June 13, 2023

Re: Supplemental Information for High Timber Resources Permit Applications –  
Responses to Questions/Comments from District Consultants

Thornhill Group, Inc. (TGI) received from you on June 5, 2023 the e-mailed transmittal of questions and comments from Ground Water Consultants (GWC) and Advanced Groundwater Solutions (AGS) regarding the High Timber Resources Aquifer Evaluation Report that TGI prepared and is dated February 10, 2023. This letter provides our responses to those questions and comments.

Revised Figure 7:  
1-Year Analytical Drawdown

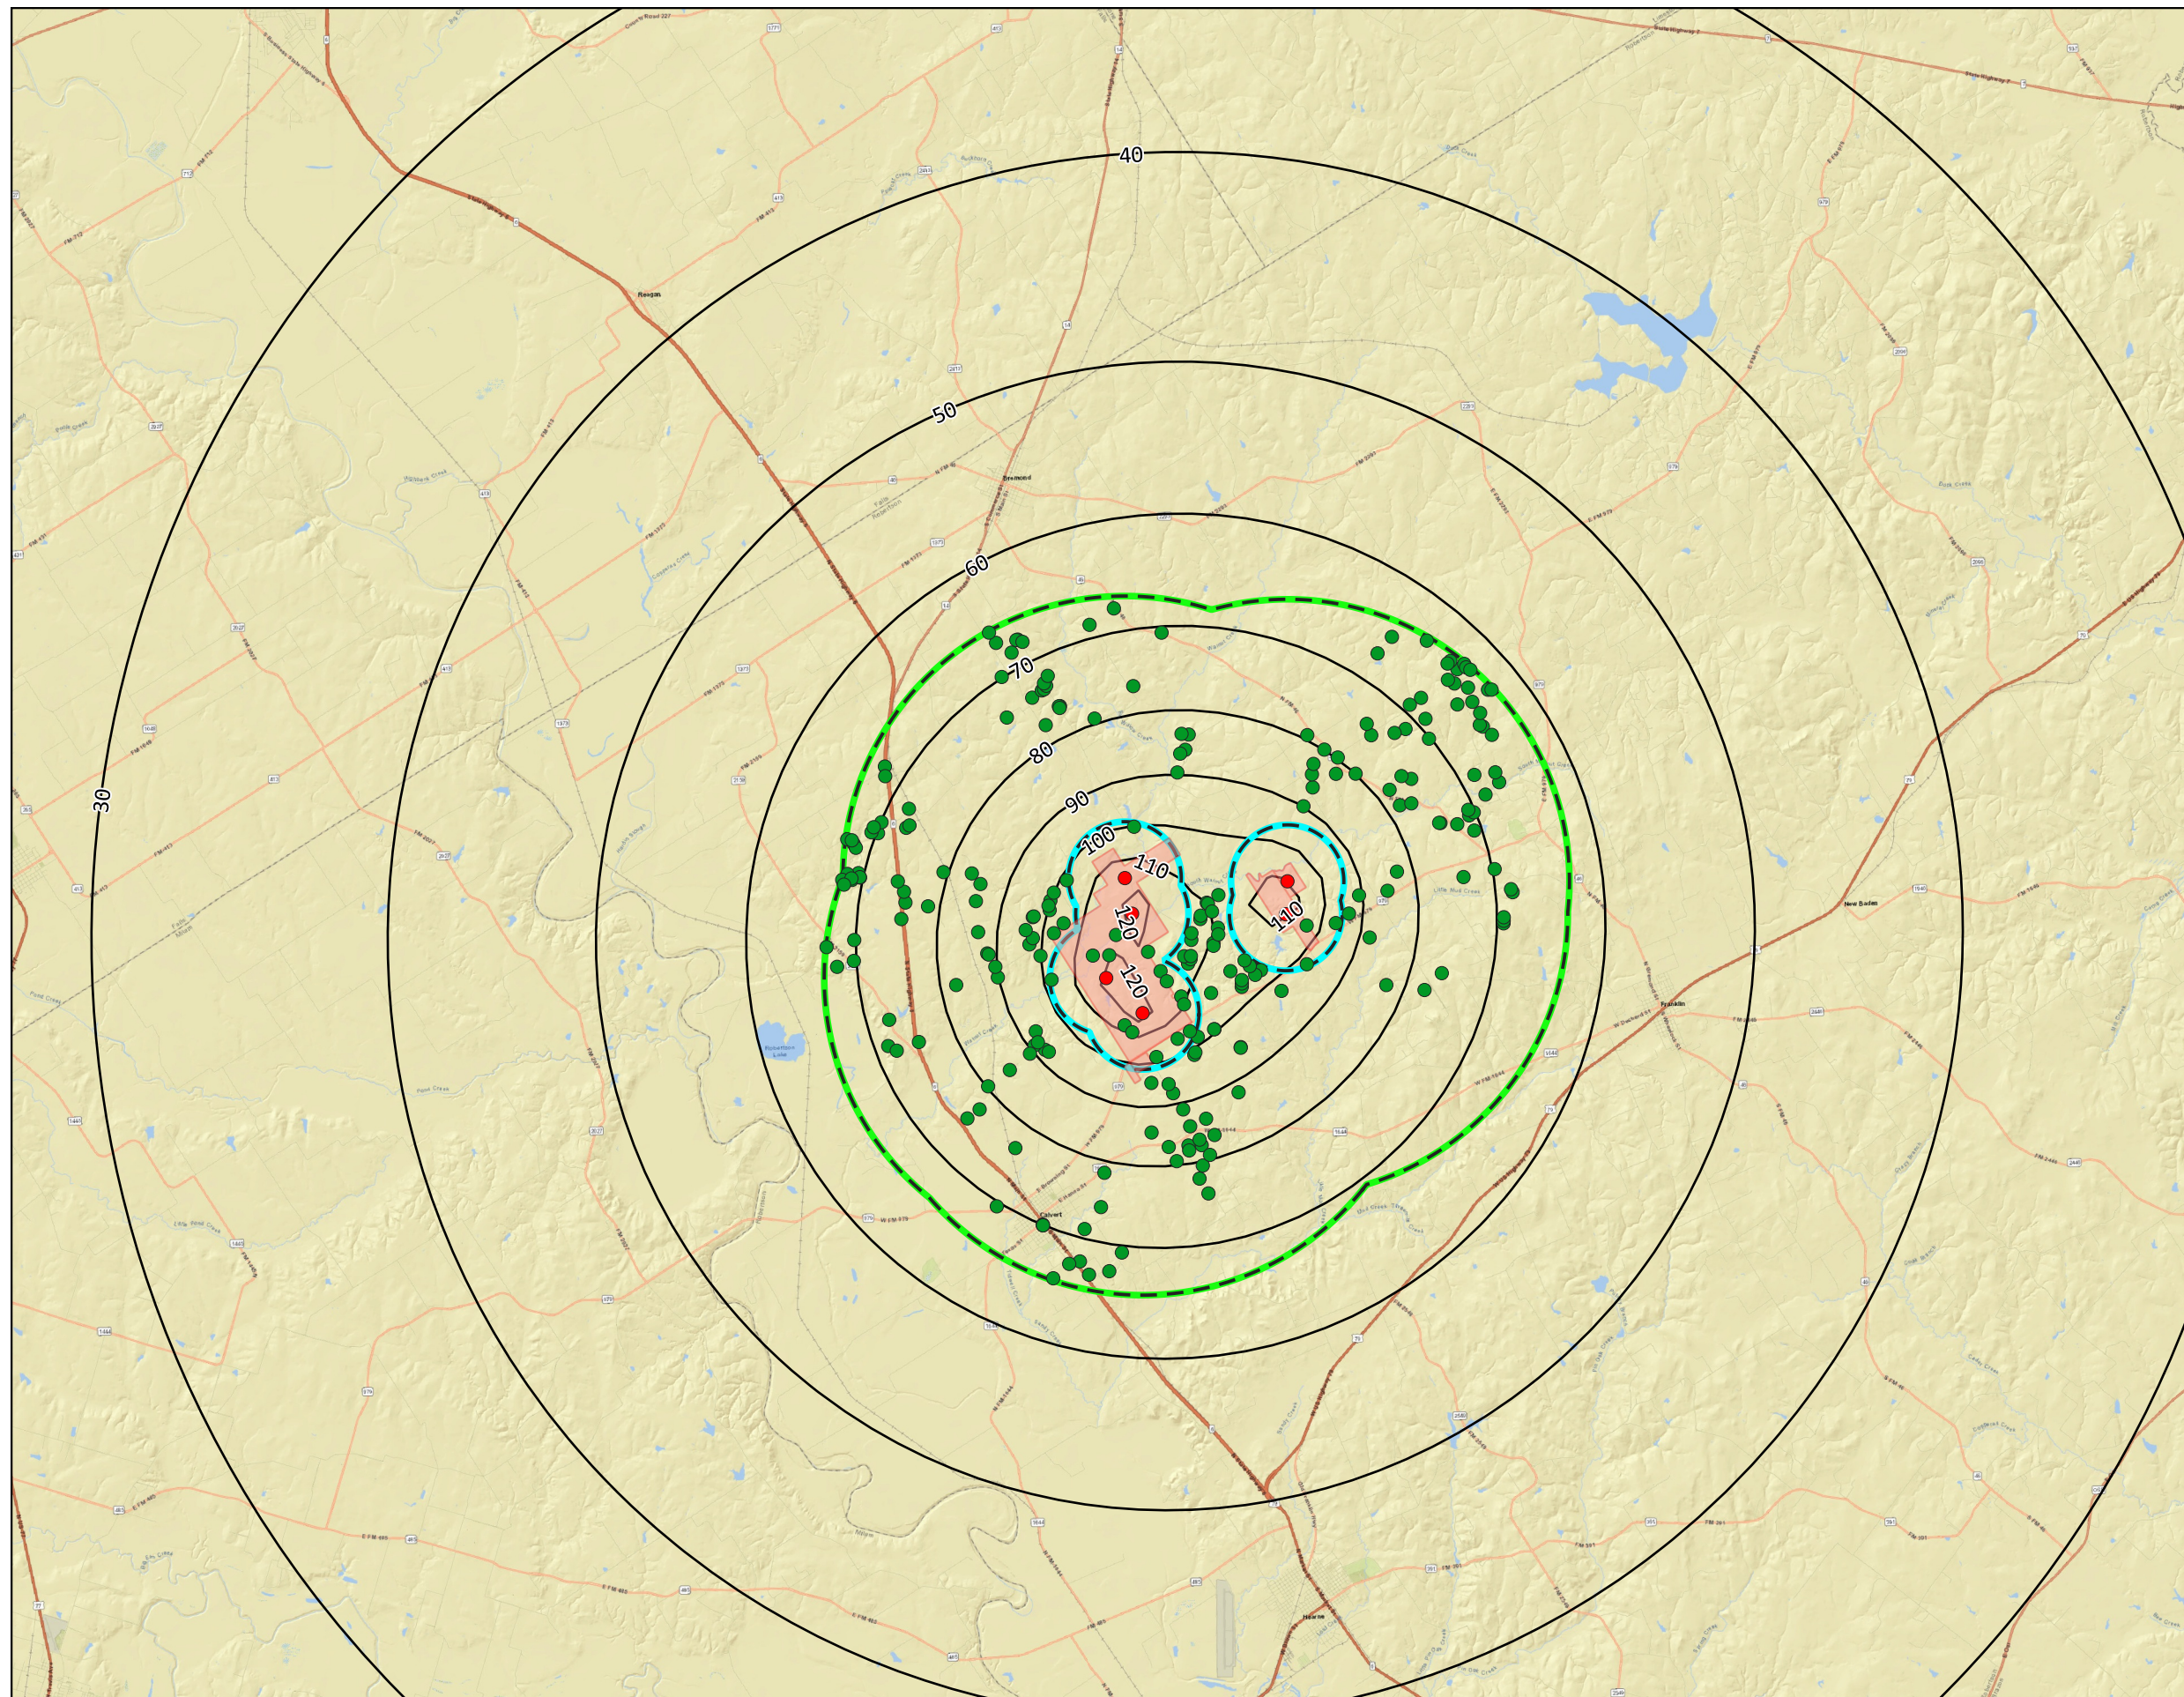
5. Please check the 1-year and 10-year analytical modeling results shown in the table on Page 7 of 8 of the TGI Aquifer Evaluation Report. Some drawdown values shown in the table on Page 7 of the TGI report are not in agreement with the contours shown on Figures 7 and 8 in the TGI Aquifer Evaluation Report.

- a. We were able to generally recreate the 1-year and 10-year analytical model results for most of the wells shown on Table 1 of the Aquifer Evaluation Report; however, there are large differences between the simulated drawdown results at the High Timber wells shown in the table on Page 7 of 8 of the TGI Aquifer Evaluation Report and the results obtained during the AGS analytical modeling verification simulations. AGS

*used the High Timber well production rates and aquifer properties outlined in the Aquifer Evaluation Report to estimate drawdown values at 1-foot from the well(s). Please elaborate on the TGI methodology, if different from the above, used to estimate the analytical model results at the High Timber wells shown in the table on Page 7 of 8 of the TGI Aquifer Evaluation Report.*

Per Item No. 4 above, TGI revised the storage coefficient and transmissivity values and re-run the analytical calculations and revised the contour maps accordingly. TGI has submitted corrections as noted in Item 5.a. below.

**Per Item No. 4 and Item No. 5 above, TGI re-constructed the analytical calculations in accordance with the methodology used in our previous reports submitted to BVGCD. We have re-drawn the drawdown maps and corrected the tabulation. Please replace Figure 7 and Figure 8 in the original Aquifer Evaluation Report with Figure 7 (Revised) and Figure 8 (Revised), respectively. Also, please replace the table on Page 7 of 8 of the original Aquifer Evaluation Report with the tabulation below.**
